Flight Procedures Cover Page	Task Action: FLIGHT CHECK	Task Type: SID	Estimated Chart Date: 02/25/2021	APWS Task ID: BFCDA8009DF44CBCBAB8B0DB9E5039E7	APWS Project ID: FF395D59E89345058D528D8533C20D02
Procedure: SID PACKK NINE RALEIGH/DURHAM NC KRDU		Enroute: YES	Specialist: Grim, Robert		Agreement Number:
Airport ID: KRDU	Airport Name: RALEIGH-DURHAM INTL		Airport City: RALEIGH/DURHAM		State: NC
Facility ID:	Facility Type:	Flight Inspection Remark Type: New FC Slot			
<p><b>Procedure Comments:</b> CONTACT INFO: DON LANIER AJV-A431 MANAGER, 405.954.8242</p> <p>03/03/20: THIS IS AN UPDATED COPY OF THE FORM DEVELOPED ON 12/16/19.  1. CHANGED MOCA FROM 3200 TO 3100 (RDU VTAC TO ROZBO, ROZBO TRANSITION).  2. ADDED NOTE TO PROCEDURAL DATA NOTES: SPECIAL INSTRUCTIONS: FOR APPROPRIATE DEPARTURE CONTROL FREQUENCY USE FREQUENCY DEPICTED WITHIN SECTOR FOR ROUTE OF FLIGHT AFTER RDU VORTAC.  3. DELETED NOTE FROM ADDITIONAL FLIGHT DATA: CHART NOTE: USE DEPARTURE FREQUENCY FOR ROUTE OF FLIGHT AFTER RDU VORTAC.  4. ADDED NOTE TO ADDITIONAL FLIGHT DATA: DIVIDE SECTORS WITH A DASHED LINE PARALLEL TO AND IN BETWEEN RALEIGH-DURHAM RWYS 5L/23R AND 5R/23L.</p> <p>06/17/20: THIS IS AN UPDATED COPY OF THE

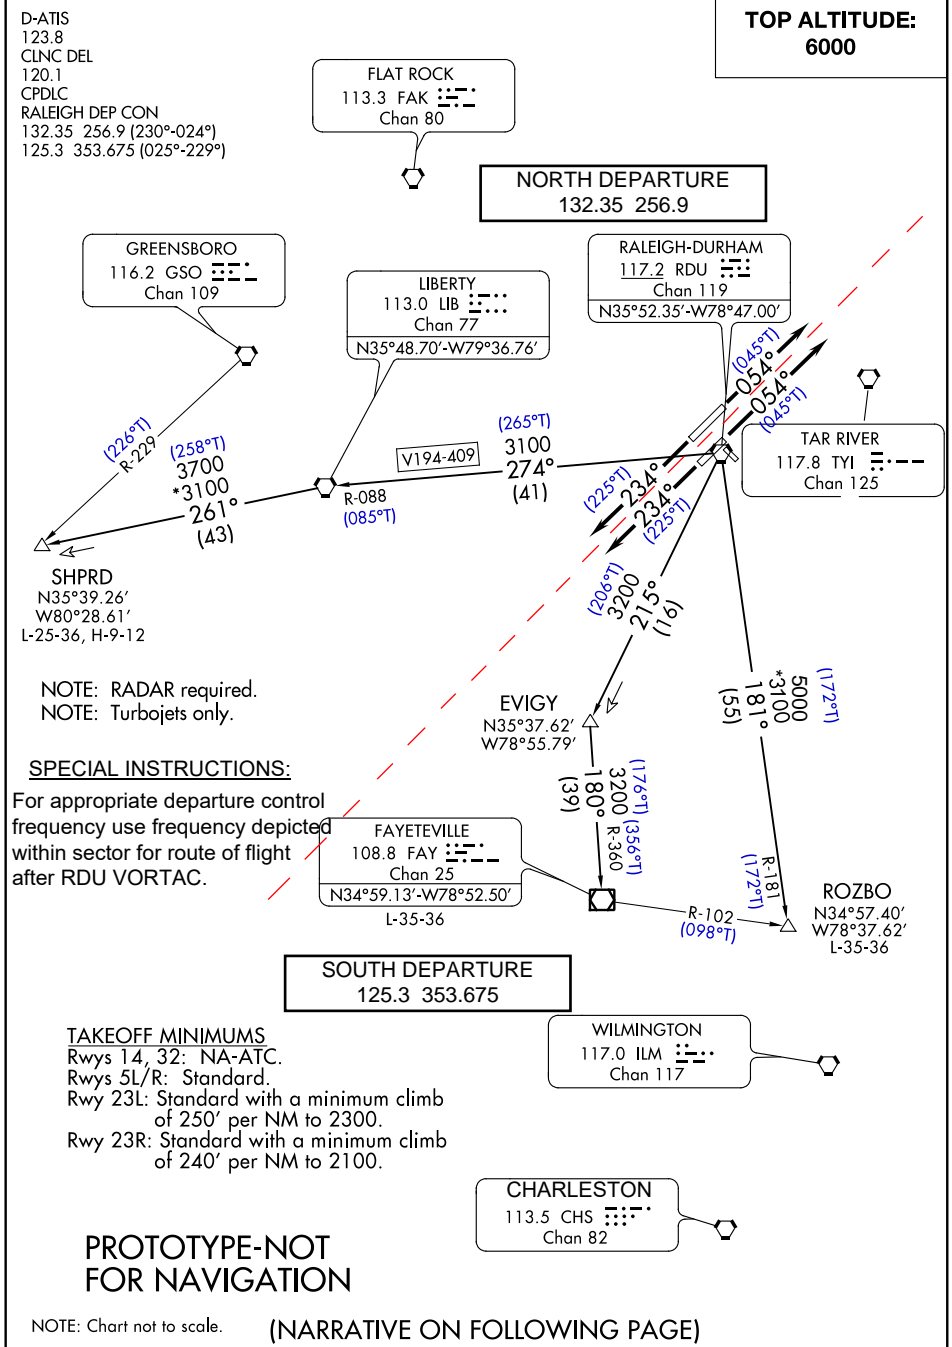
<b>FLIGHT INSPECTOR SIGNATURE:</b> john kearby @ 02/20/2020 15:17			<b>PRINTED NAME:</b> KEARBY, JOHN DAVID			<b>NOTAM INITIATED?</b> <input type="checkbox"/> YES <input checked="" type="checkbox"/> NO
<b>FLIGHT INSPECTOR REMARKS:</b> Is MOCA between RDU and ROZBO 3100 or 3200? See RALEIGH ONE SID procedure packet						
<b>IN-FLIGHT OBSTACLE REPORT</b>						
<b>OBSTRUCTION ID #:</b>	<b>COORDINATES OR LOCATION:</b>	<b>GNSS ALTITUDE (MSL):</b>	<b>BAROMETRIC ALTITUDE (MSL):</b>	<b>HEIGHT ABOVE GROUND LEVEL:</b>
